EO 55-45-6A

5 Jun 69

LIST OF FIELD MODIFICATIONS
SAFETY HARNESS - GENERAL

Figure 1

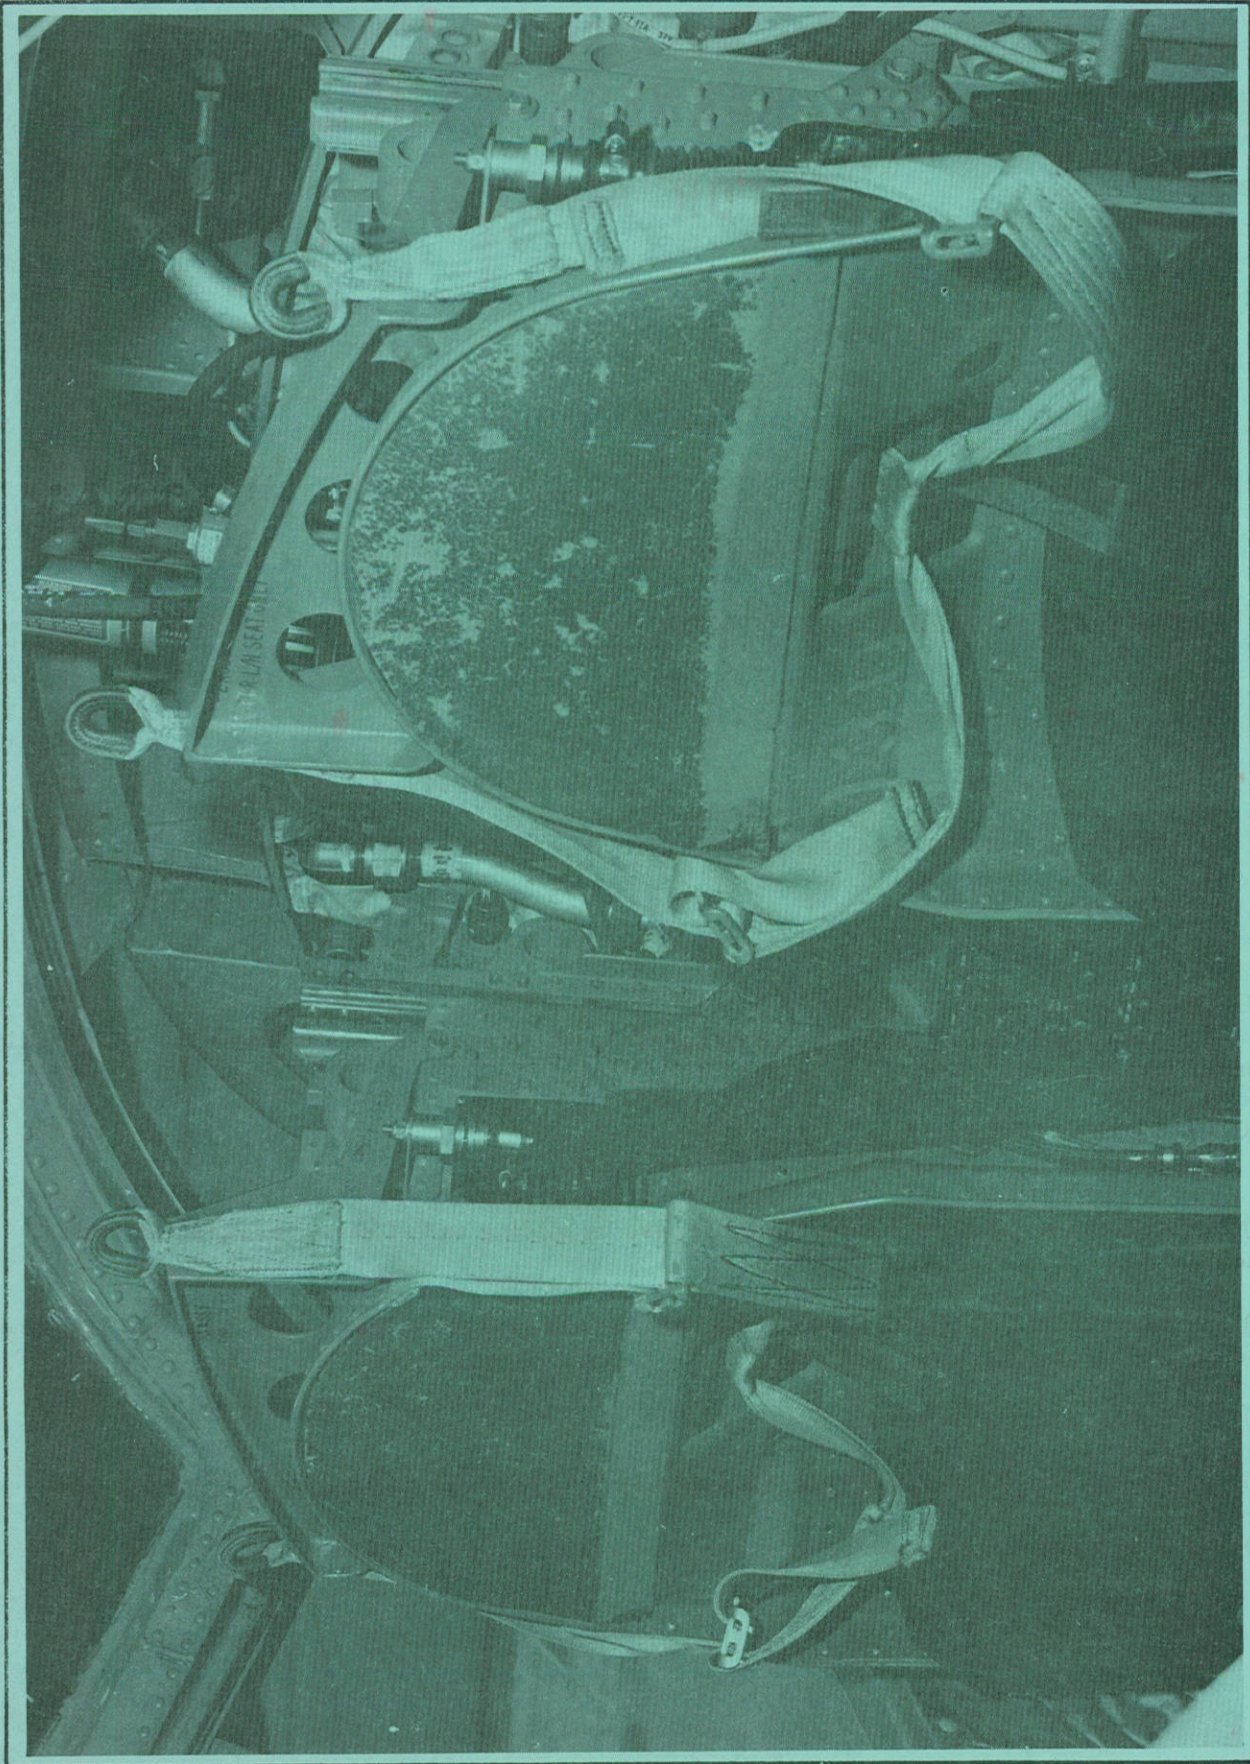
- (a) Remove adjustable straps from harness by sliding end of strap through adjustment buckle.
- (b) Sew a 2" x 1" strip of Velcro pile onto the strap midway between attachment loop and end of sewing on outer face of strap.
- (c) Install adjustable straps.
- (d) Glue a 2" x 2" strip of Velcro hook to each side of the canopy breaker on the seat.
- (e) Carry out same sequence on other seat and shoulder harness.

Figure 1

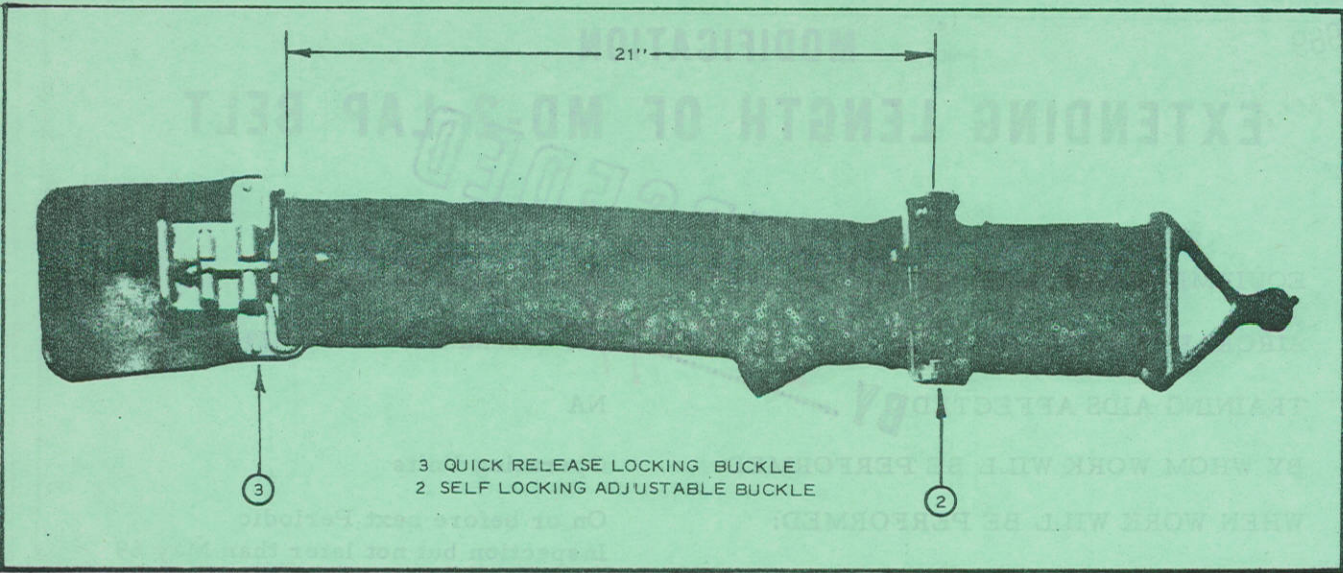
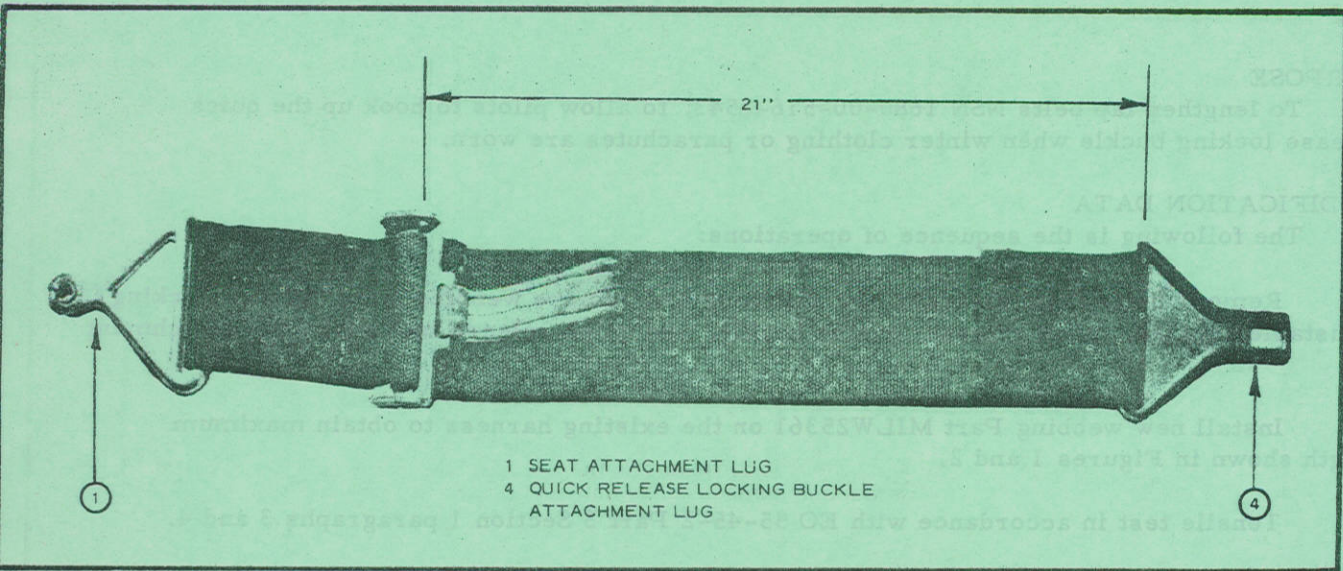
- (a) Remove belts from aircraft. Cut stitching and remove webbing from the self-locking adjustable buckles, quick release locking buckle, and quick release locking buckle attachment lug.
- (b) Install new webbing Part MILW25361 on the existing harness to obtain maximum length shown in Figures 1 and 2.
- (c) Tensile test in accordance with EO 55-45-2 Part 3 Section 1 paragraphs 3 and 4.
- (d) Re-install in aircraft.

Stitching is to be not more than six and not less than five stitches per inch, back stitched not less than 3/4".

Figure 1

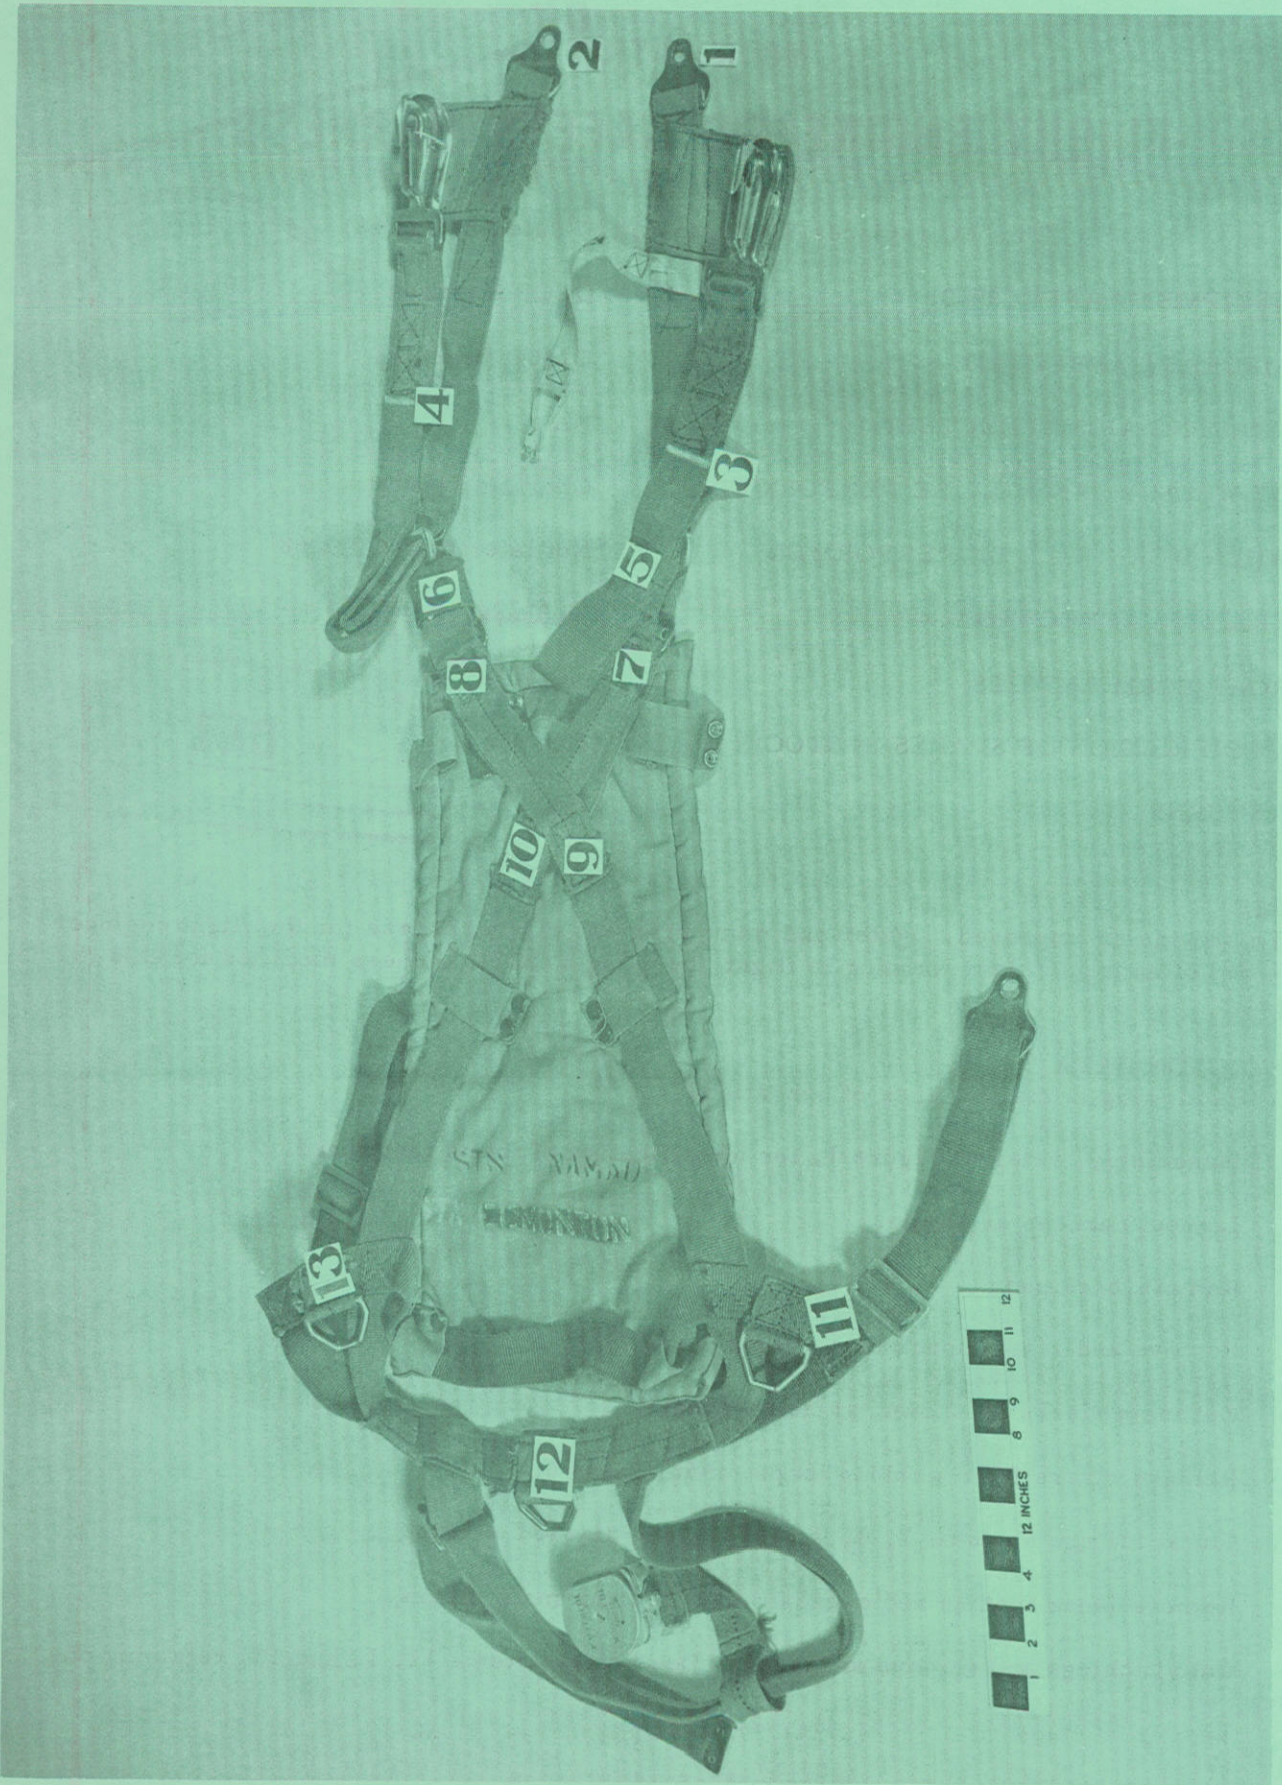
- (a) Disassembly, refer to Figure 1, for identification of items mentioned.
 - (1) Lay out harness as shown.
 - (2) Remove back pad.
 - (3) Remove and retain upper lugs, items 1 and 2.
 - (4) Cut main risers as shown, at items 3 and 4.
 - (5) Remove risers from webbing loops, items 5 and 6.
 - (6) Cut stitchings at items 7, 8, 9, and 10, and discard webbing.
 - (7) Remove loose fittings and excess material from main risers.
 - (8) Cut stitchings and remove anchorage "Dee" rings, items 11, 12 and 13, retaining one (1) "Dee" ring.

Figure 2

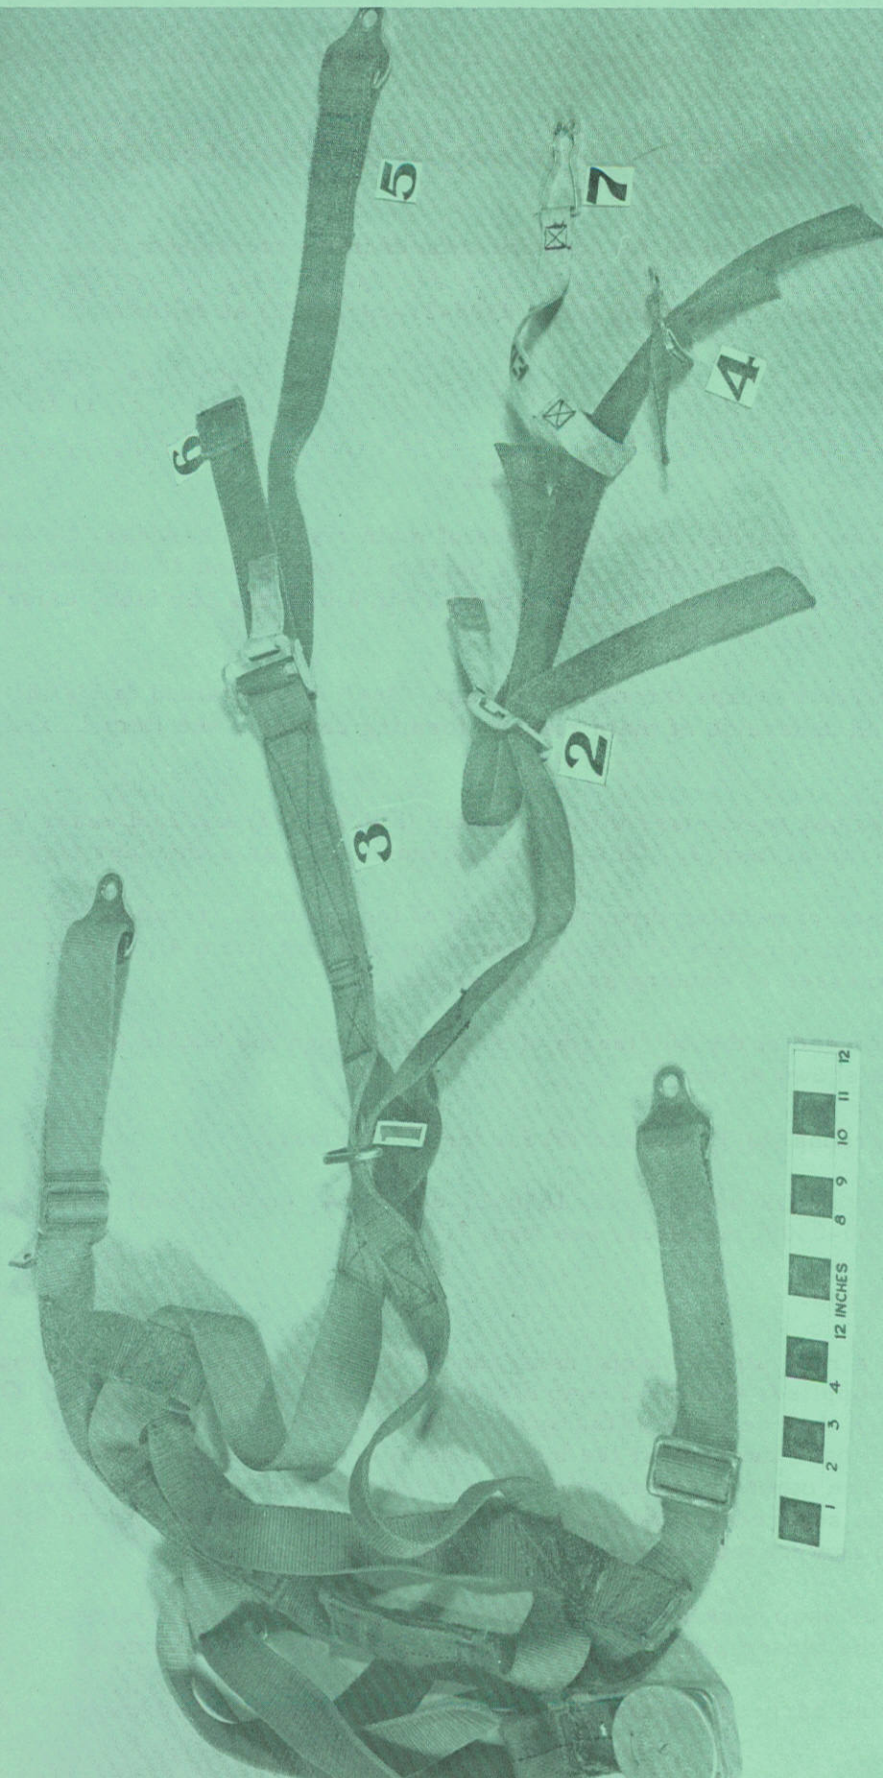
- (9) Manufacture a restraining strap, using the 11 ft. length of 2" nylon webbing, the "Dee" ring, and the buckle supplied, and the 2 snap hooks retained in paragraph 2(a)(9). The webbing shall be passed through the eye slots of the snap hooks, and through the "Dee" ring and adjusting buckle. Fold back the ends at the buckle and at one snap hook a distance of 6" and sew as instructed above. The other snap hook and "Dee" ring will remain free as shown in Figure 3, to allow the strap to be secured around any suitable fixture, or "snapped" to the aircraft floor rings, (with pressure against the strongest part of the snap hook).

- (10) Secure "fixed" snap hook to harness "Dee" ring as in Figure 3, and spot-weld the tongue of the hook in the closed position, to prevent loss of strap from harness.

Figure 1 Safety Harness Type MA6

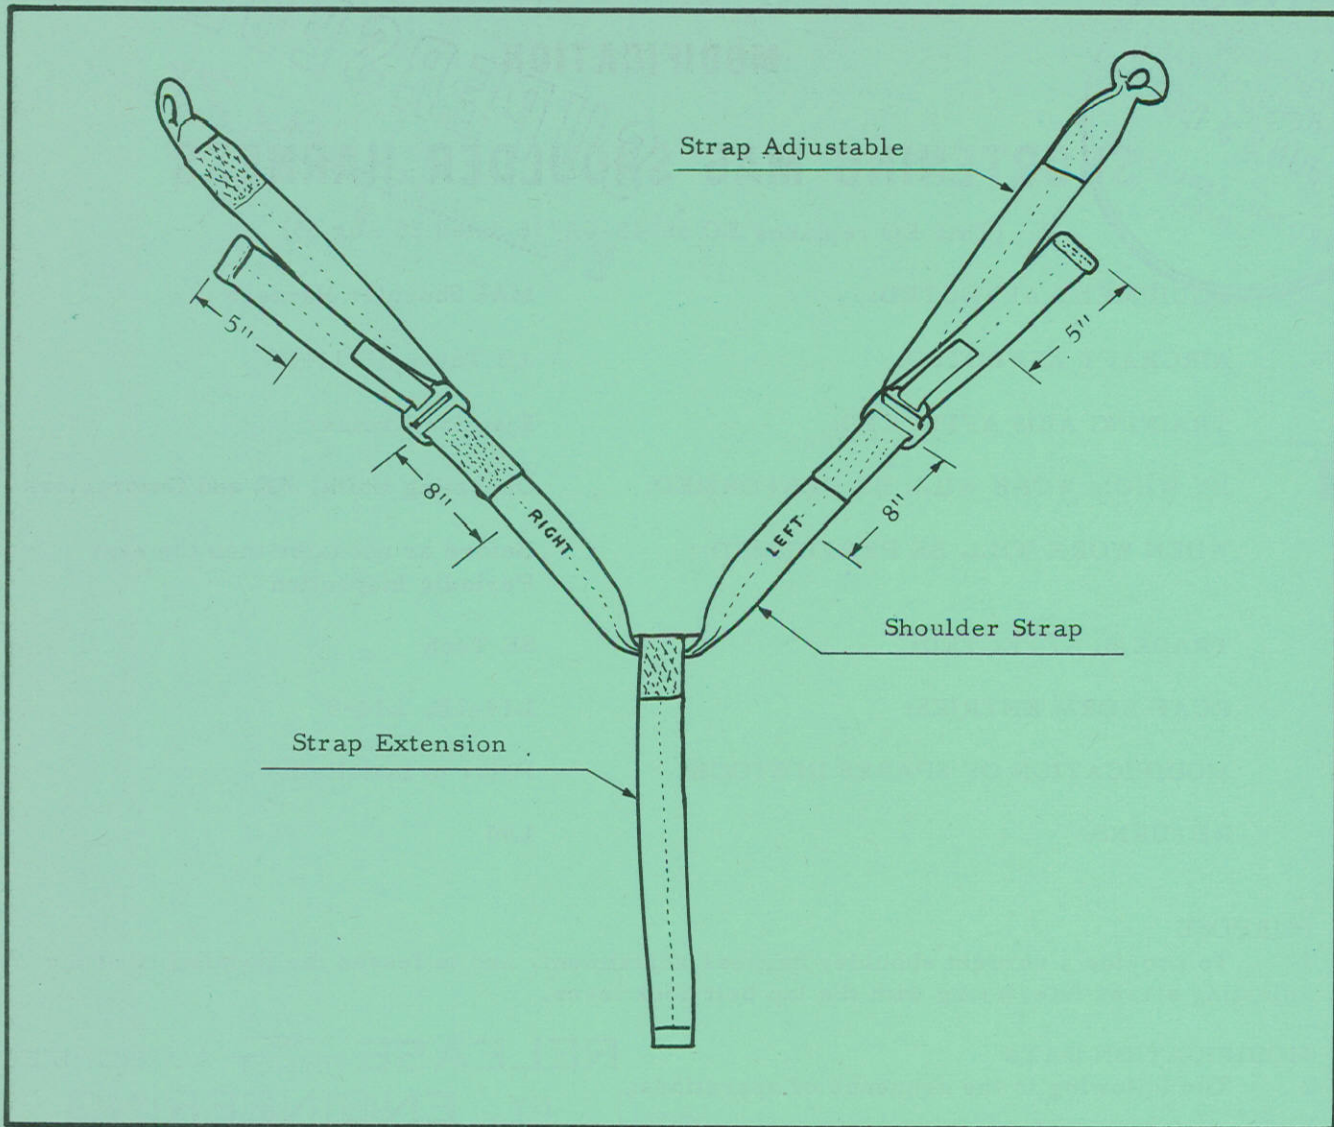
- (a) Remove the inertia reel from the ejection seat.
- (b) Measure 5" from the free end of each adjustable strap, and cut off. Remove the shortened straps from the shoulder harness and retain for re-installation, see Figure 1.
- (c) Measure 8" from the slot of each quick release adjustable buckle, and mark the harness, see Figure 1.
- (d) Carefully cut the stitching and move the end of the webbing to the previously marked location. This should result in a double portion, approximately 6" in length.
- (e) Oversee the folded end with a double "W" pattern, using thread nylon, #3, 6 to 8 stitches per inch.
